Edgemere Subdivision: Planned Unit Development Narrative Updated Per P&Z Comments

April 13, 2026

### **Edgemere Subdivision**

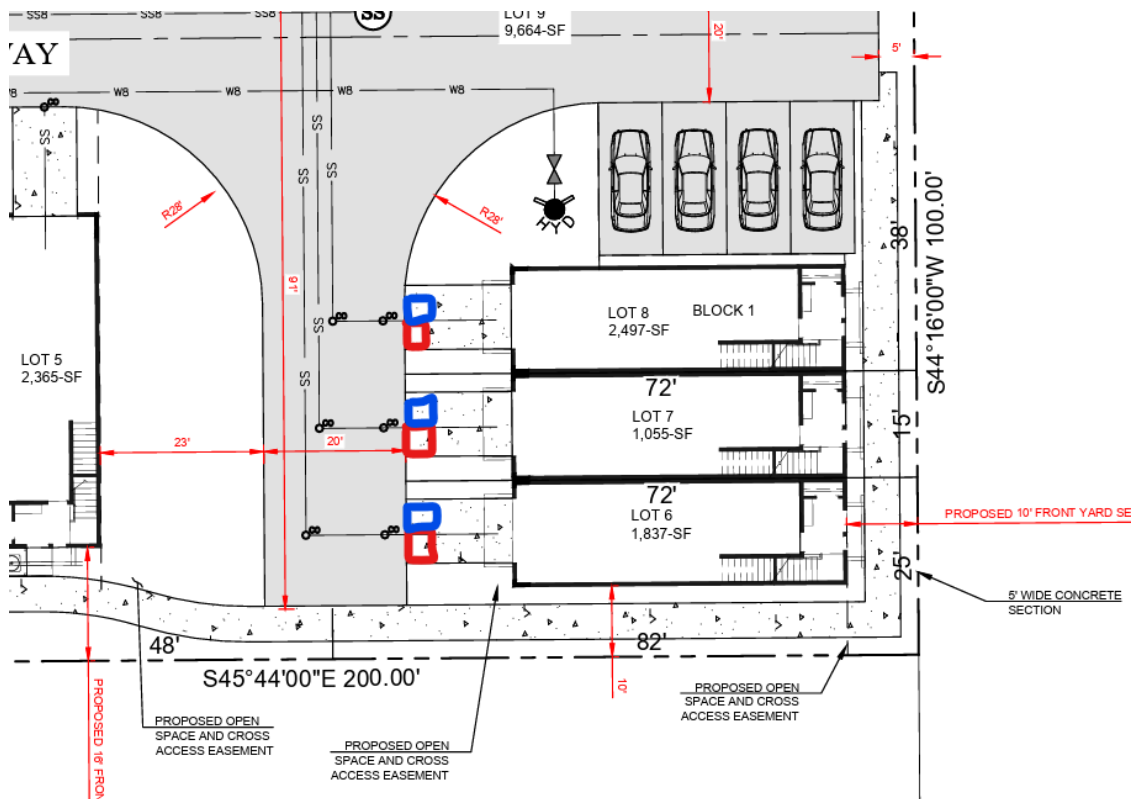
Okay, good to know! Just to clarify (a city council member had this specific question); Any concerns with lots 6 - 8 now that they are turned 90 degrees? The blue and red squares are where we had previously shown the trash carts at the end of the driveway but the concern raised at city council was "how would the truck pick up these carts if the arm is on the right/passenger side of the truck and the carts are on the left." (assuming that the truck was to drive directly into the turnaround area). Any concerns with this?

That is a valid concern. The driver will need to use all 3 segments of the hammerhead to turn the truck around. With the claw on the right side, the driver might as well back down that way to grab the carts and then proceed forward.
